8. Well Name and No.
PICKETWIRE 5 FEDERAL COM 0019. API Well No.
30-015-3595910. Field and Pool, or Exploratory
PAVO MESA11. County or Parish, and State
EDDY COUNTY, NM**SUBMIT IN TRIPLICATE - Other instructions on reverse side.**

SEE Attached

RE: Picketwire 5 Federal Com #1
660' FNL & 1650' FWL, Section 5, T17S-R29E
Eddy County, New Mexico

Approval is subject to the following changes:

Picketwire 5 Federal #1

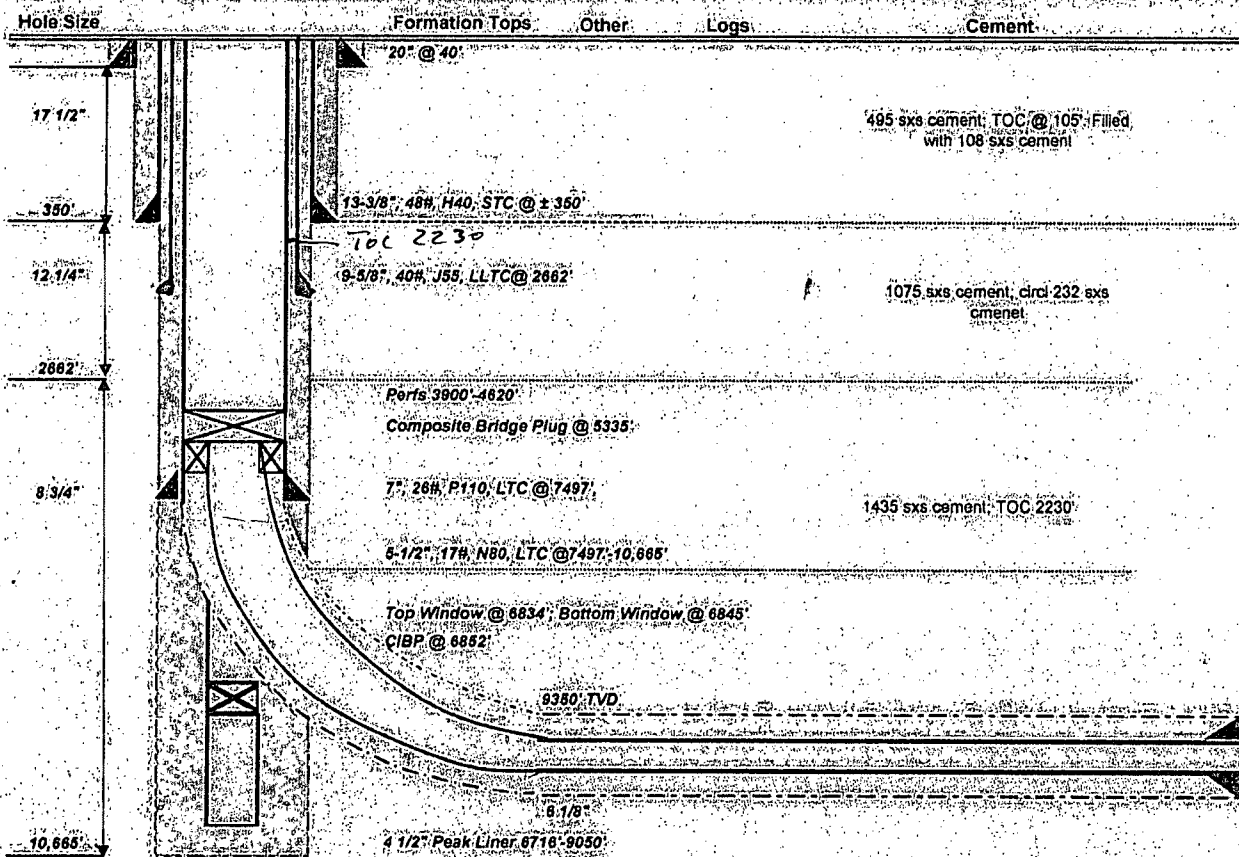
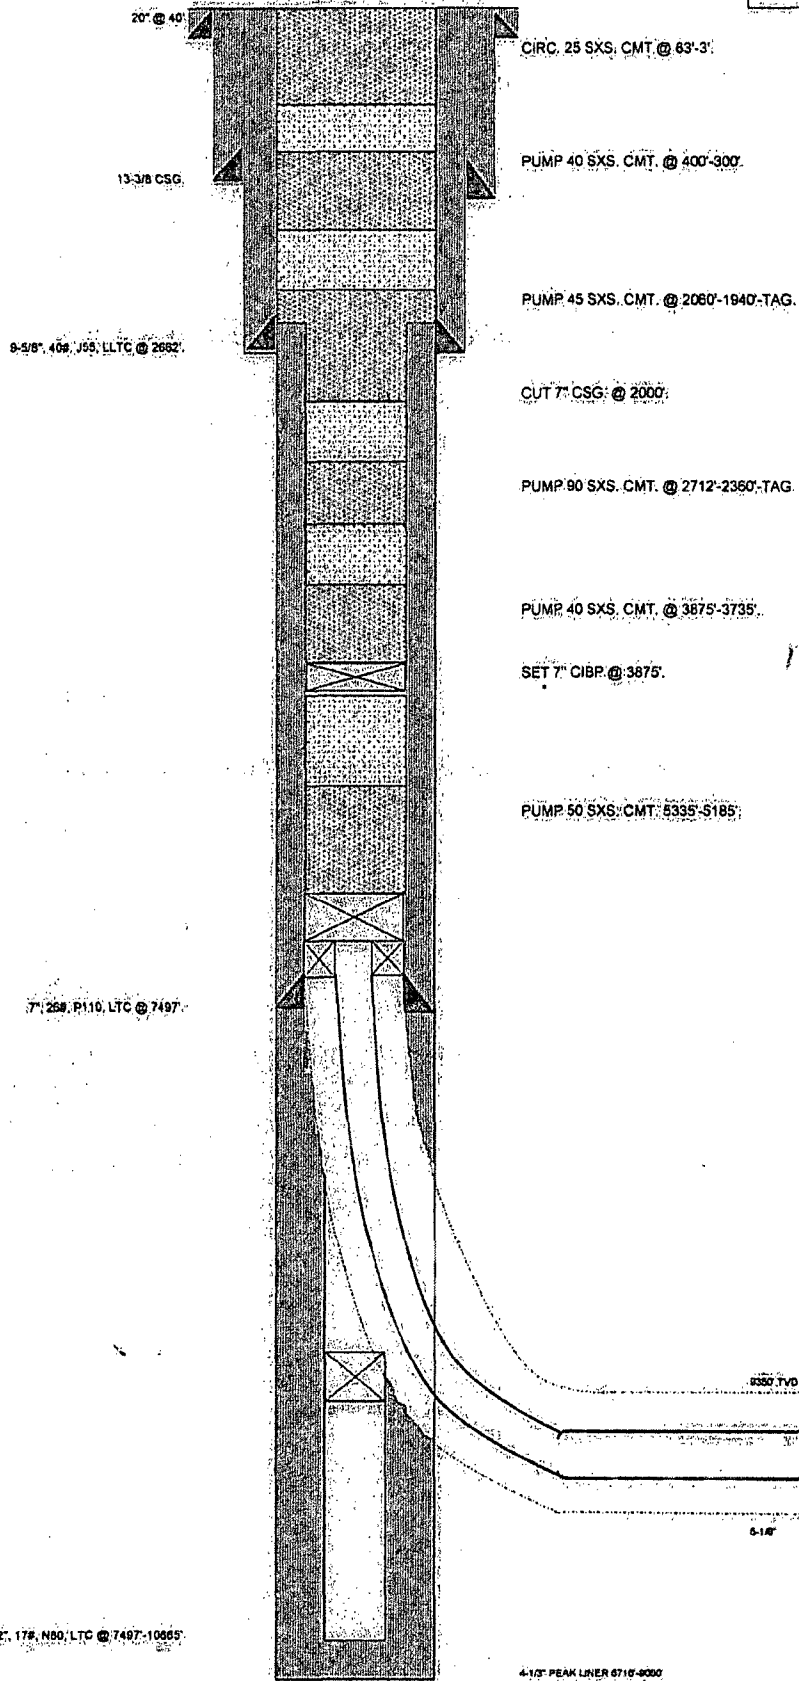
Drill out CBP @ +/- 5335', spot plug from 7547'-7377' (25 sx minimum). WOC tag.

Spot plug from 6766'-6596' (25 sx minimum). WOC tag.

Spot plug from 5935'-5775' (25 sx minimum).

Add plug from 900'-800' (25 sx minimum). WOC tag.
